San Antonio Water System
(DSP) Somerset Facility – High Service Pump Upgrades Project
SAWS Job No. 12-6101
SAWS Solicitation No. B-13-059-DD

ADDENDUM NO. 2

August 30, 2013

Consulting Engineer: Tetra Tech, Inc
TBPE Registration No. F-3924

8/30/2013 1:00:38 PM - R:\TETRA TECH\SOMERSET GST\RESTART USING SAWS STANDARDS\BID SET\ADDENDUM #2\DRAWINGS\ED 101 - ELECTRICAL DEMOLITION PLANDWG - STEVEN GRAF

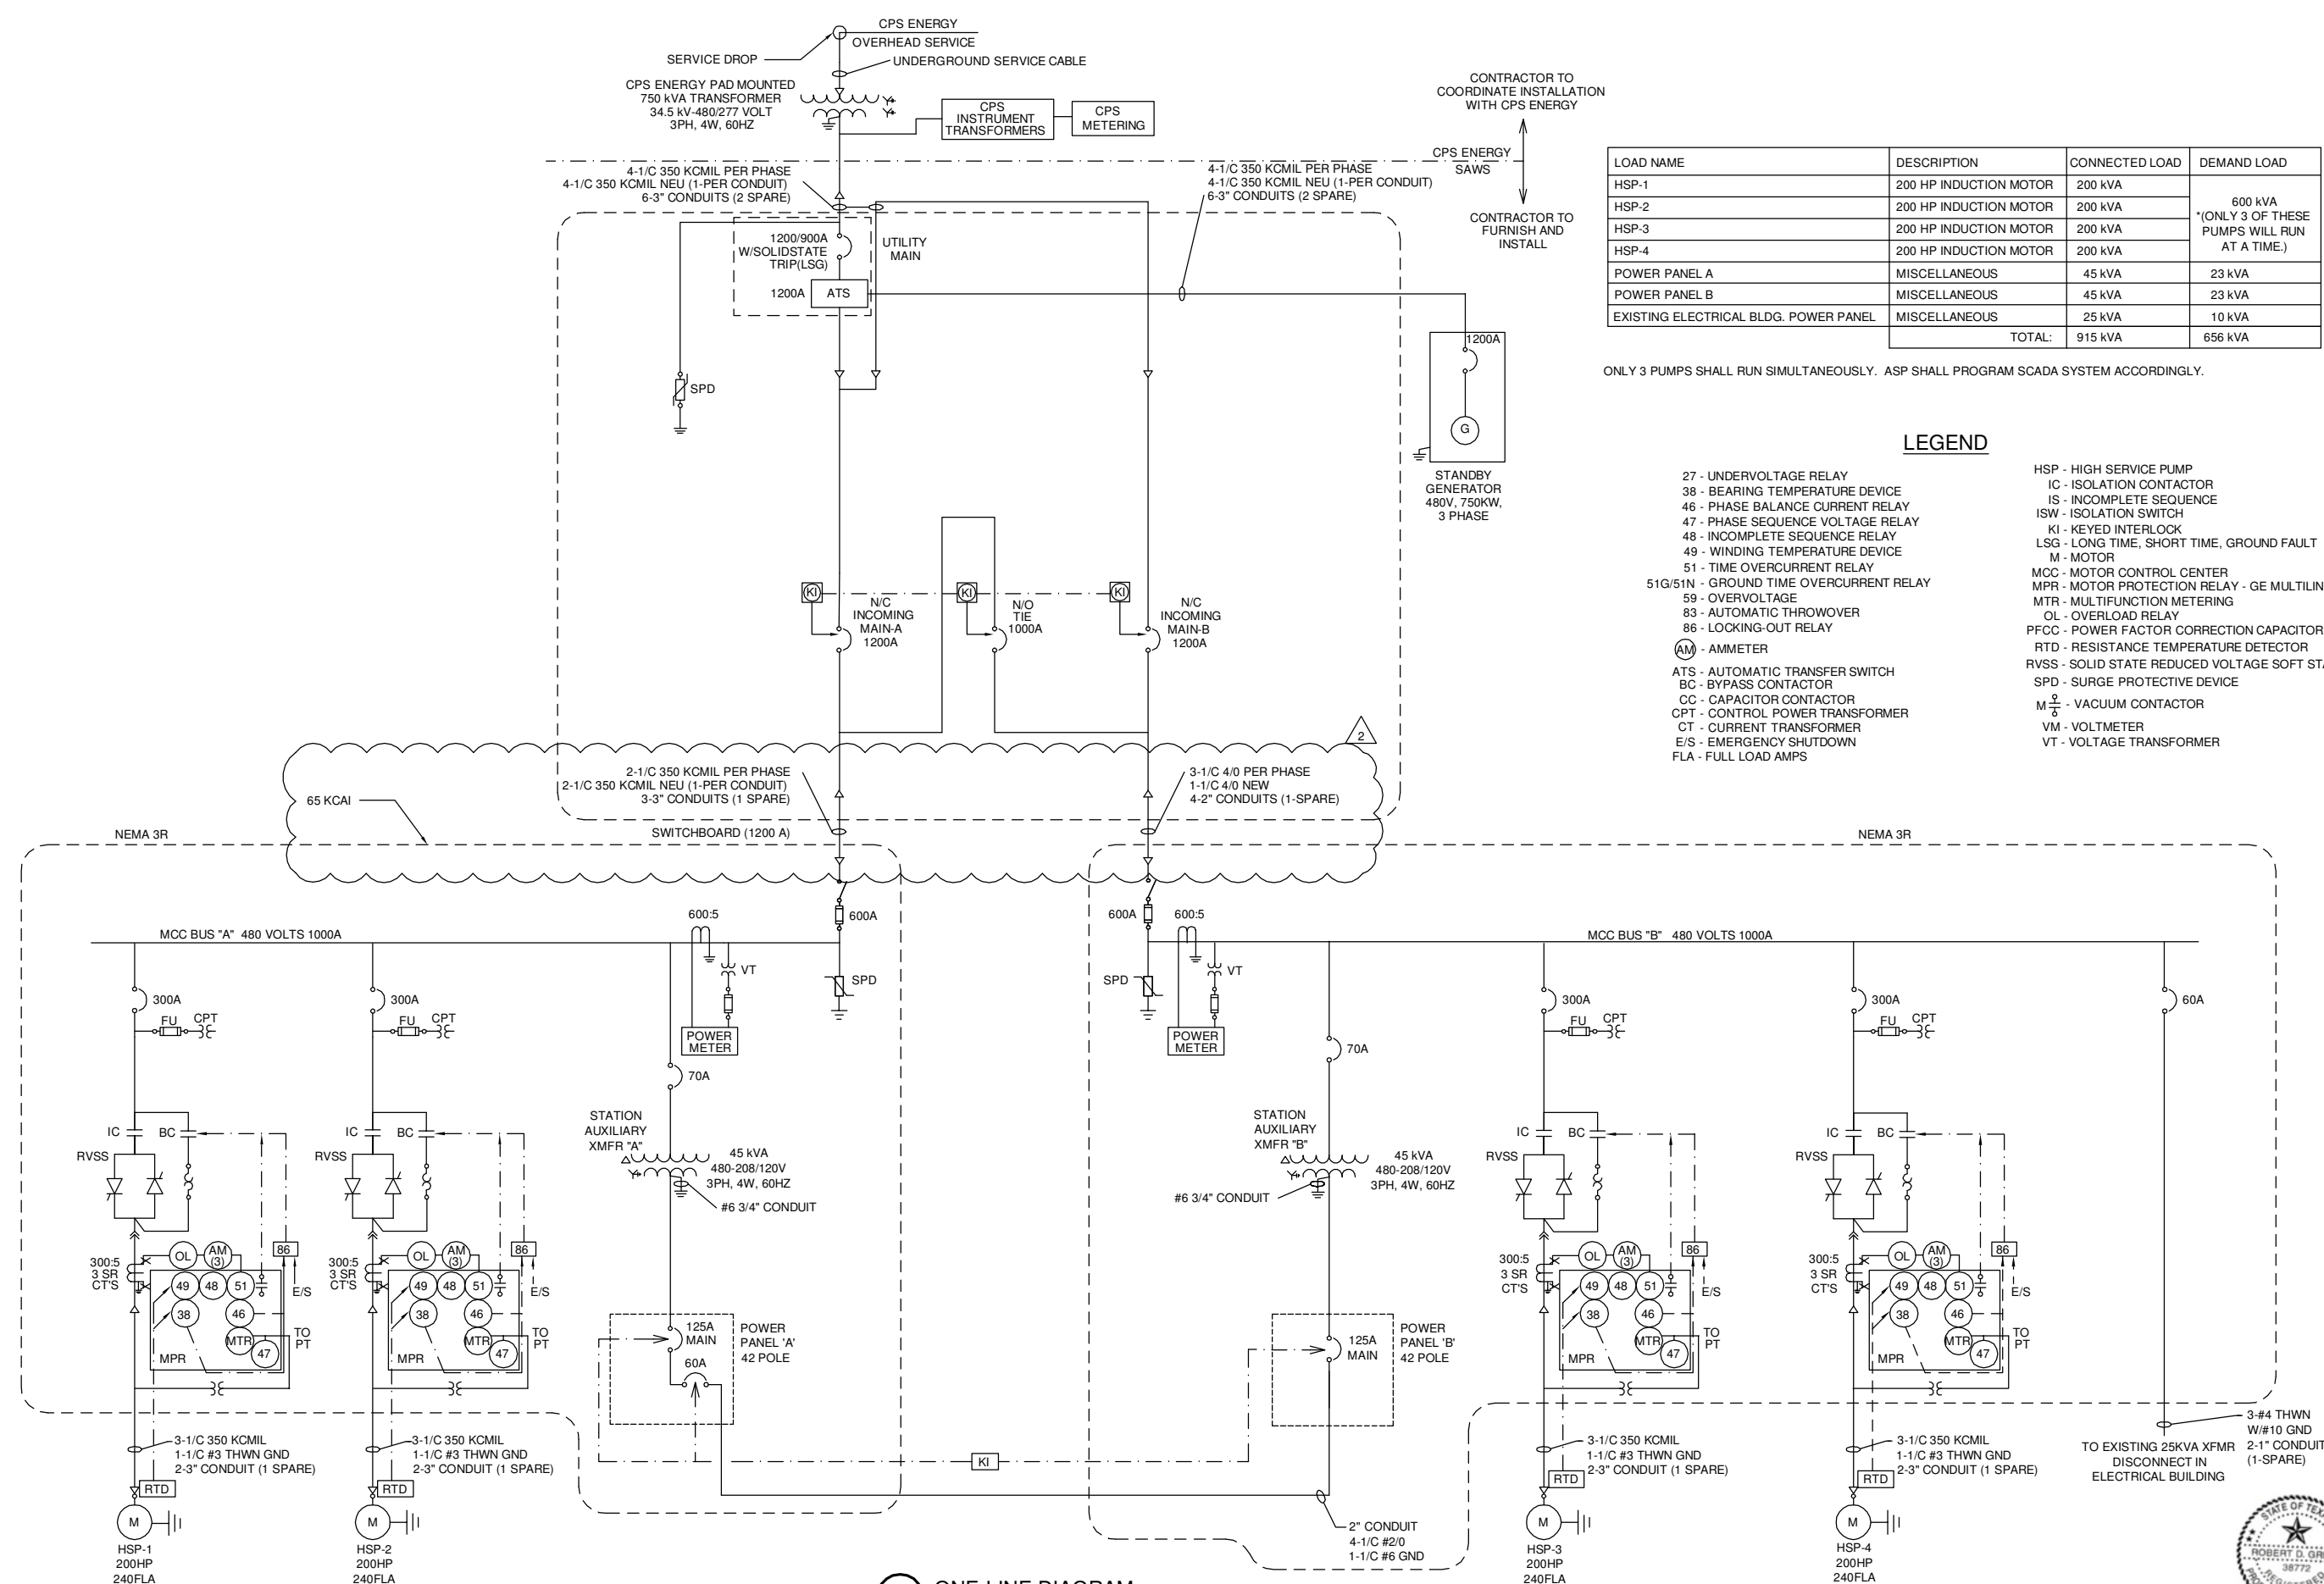
- b. Provided “Trench Detail Within TxDOT ROW”
6. Sheet D-100 (9 of 70): Revise note pointing to the existing well to read, “Demolish pipes and electrical features up to the wellhead.”

E-101
Sheet 03 of 26

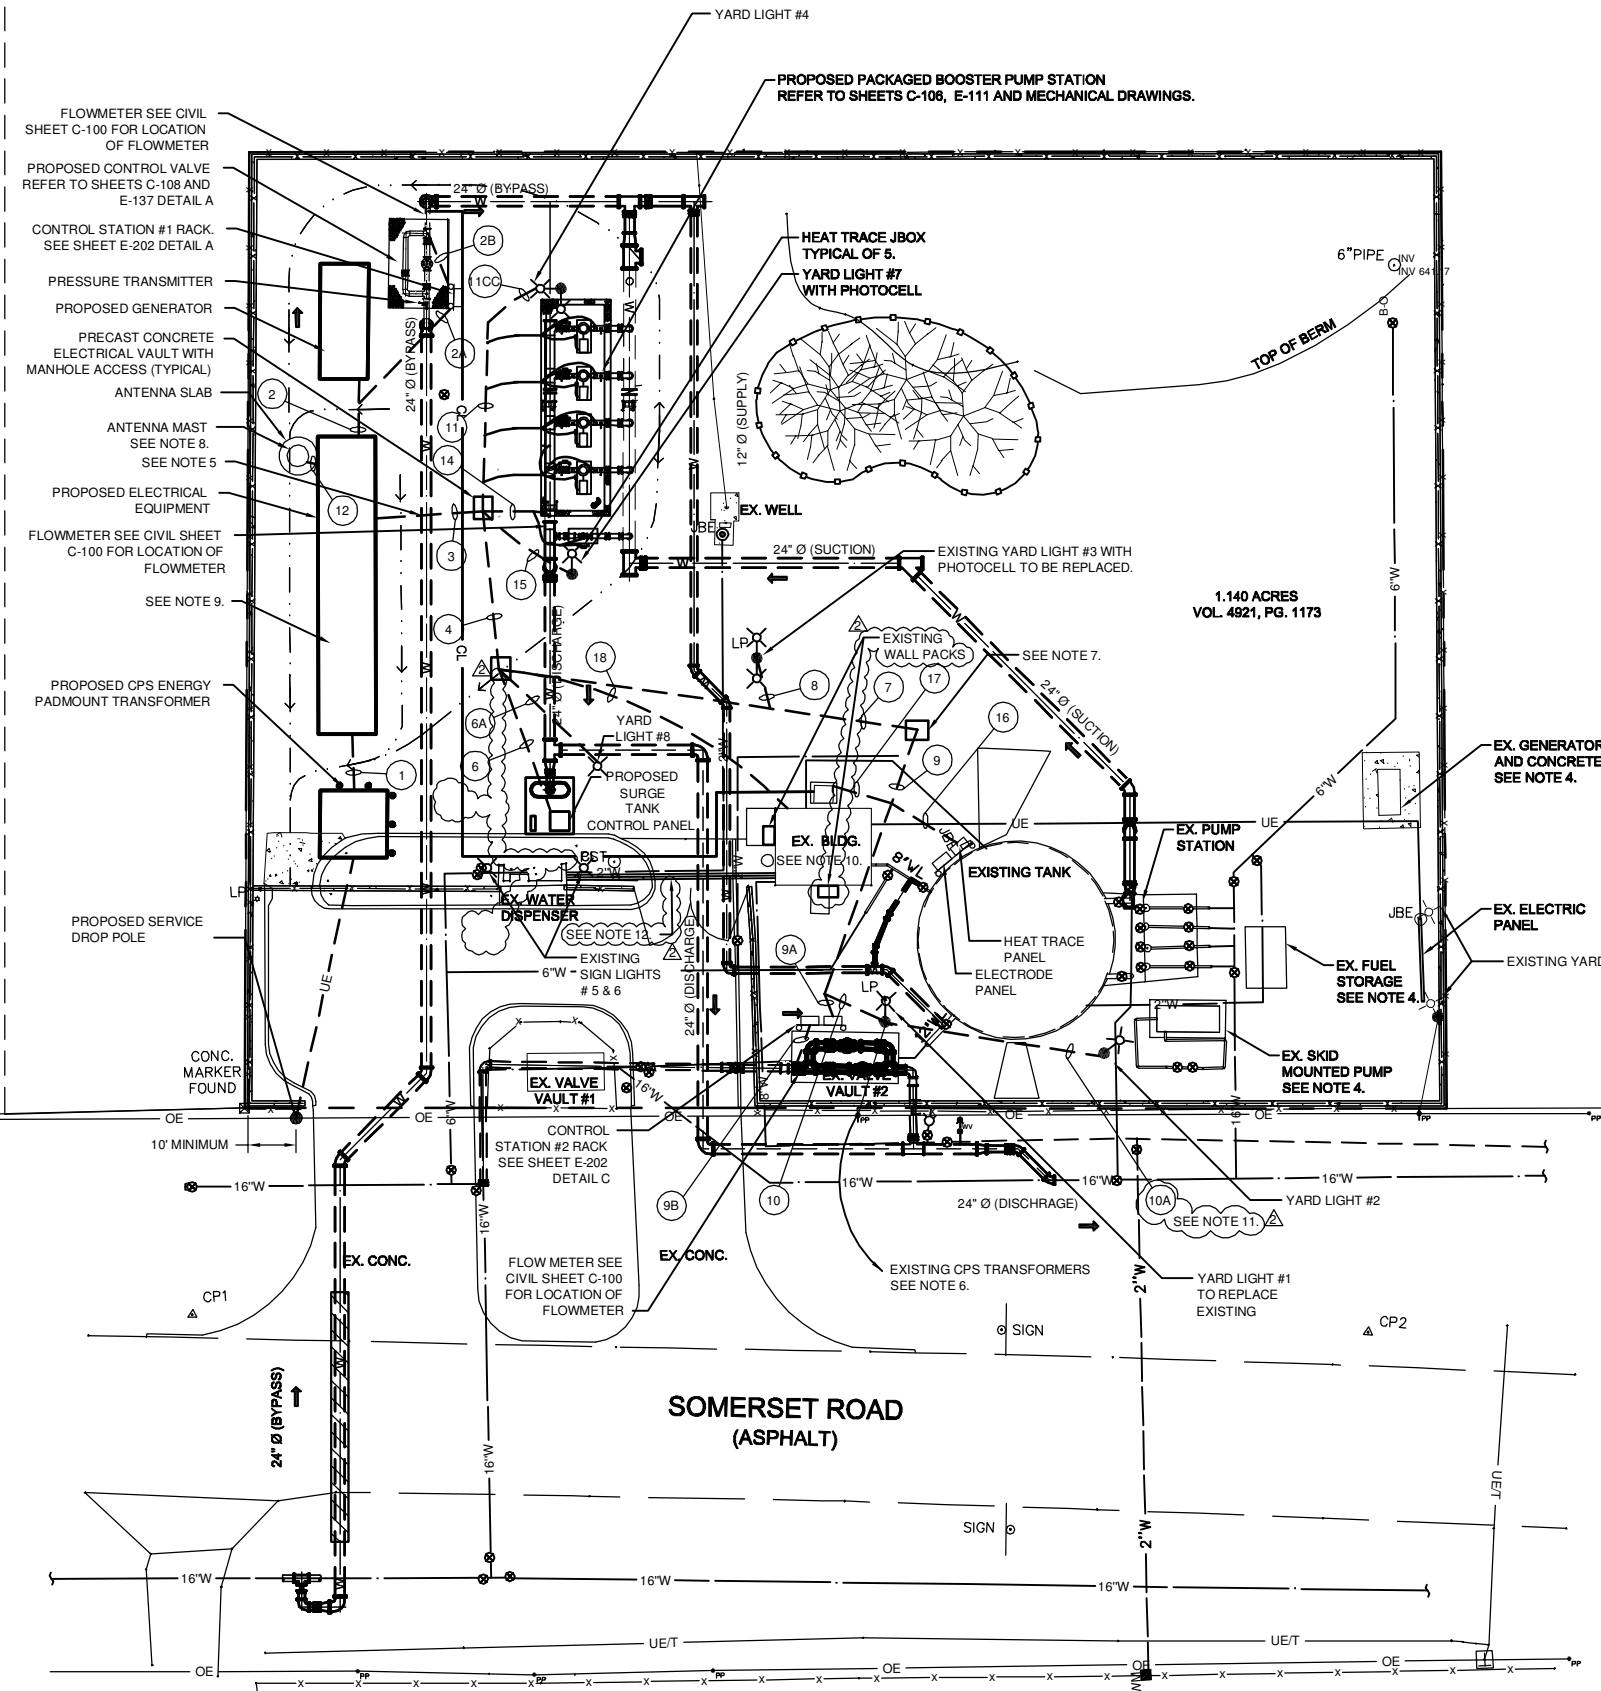
2) The Switchboard enclosure and the Motor Control Center enclosures are different heights. Since this will be mounted outdoor, I am concerned that rain will get into the enclosures. I have 2 - possible solutions

- a) Have a cable connection from the Switchboard sections and the Motor Control Centers
- b) Have all equipment mounted into Motor Control Center construction (not switchboard construction).

19-1) Drawing E-101 shows INCOMING MAIN-B bussed to MCC BUS "B", but Drawing E-140 shows the ATS/Main in between the INCOMING MAIN-B and MCC BUS "B". Should the INCOMING MAIN-B be bussed to MCC BUS "B" and place the ATS/Main at the end of one of the MCC Lineups?

The first solution is acceptable. The Switchboard/Motor Control Center configuration has been modified accordingly. Please refer to revised one line diagram on sheet E-101.

The Switchboard /Motor Control Centers connection has been modified to reflect cabled instead of bussed. Refer to revised drawing E101. Therefore, the ATS location per sheet E-140 does not need to change.

A 480V MCC/SWITCHBOARD TOP VIEW

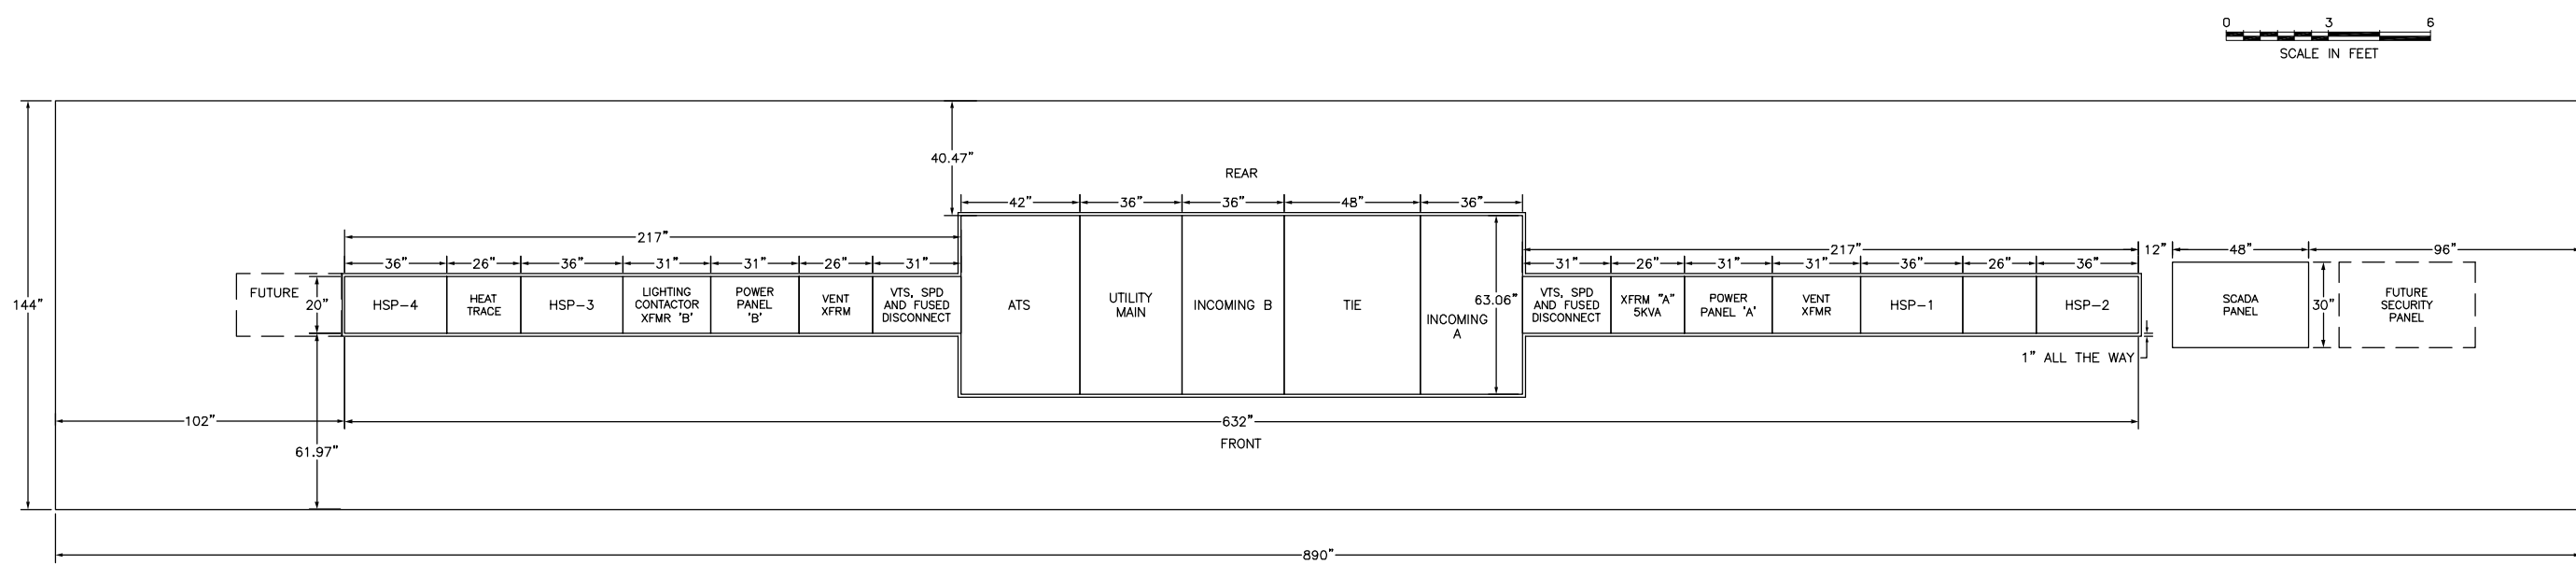
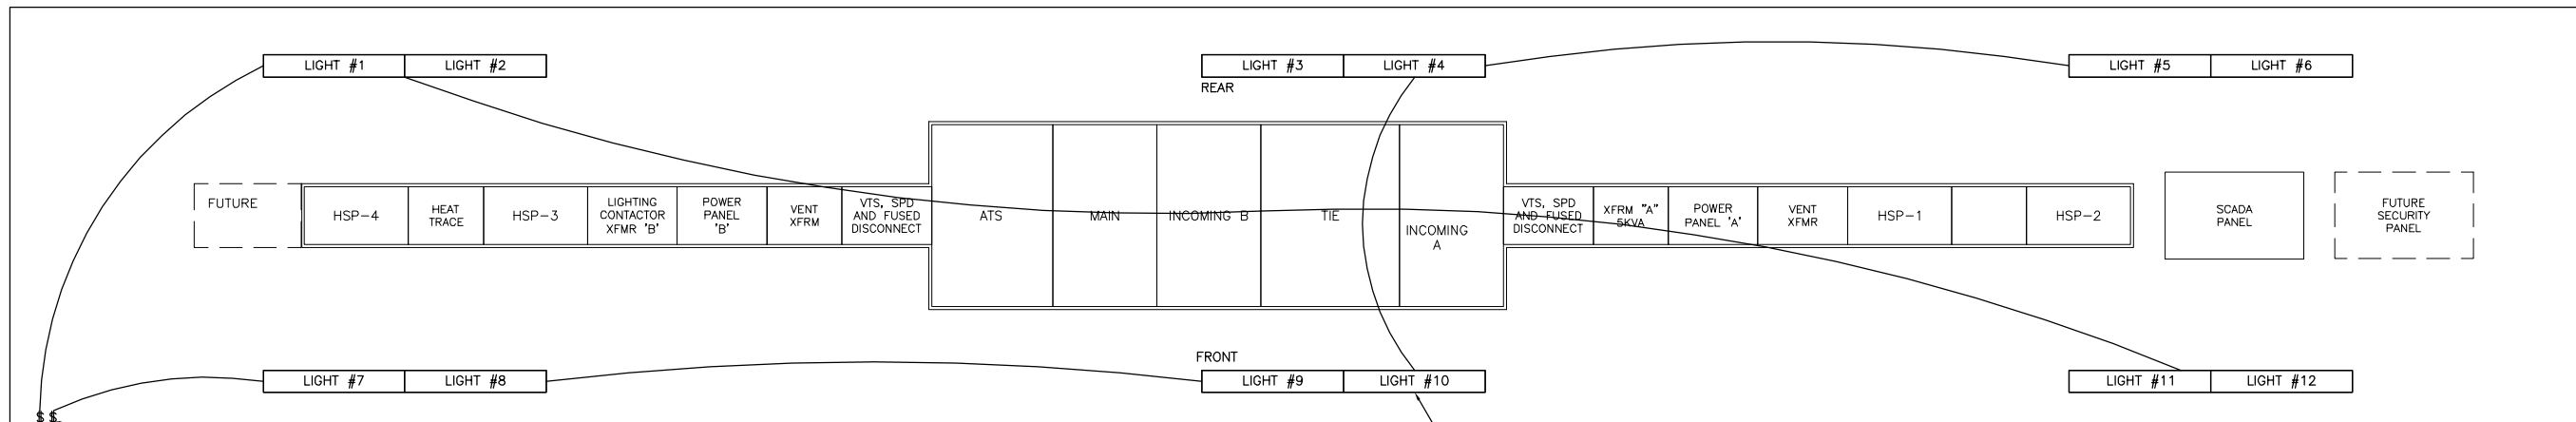
2. “- Drawing E-140, Section B makes reference to “Canopy Lighting Layout”. Is a canopy to be provided over MCC? If so, please provide specifics.”

Canopy details were provided in Addendum No. 1
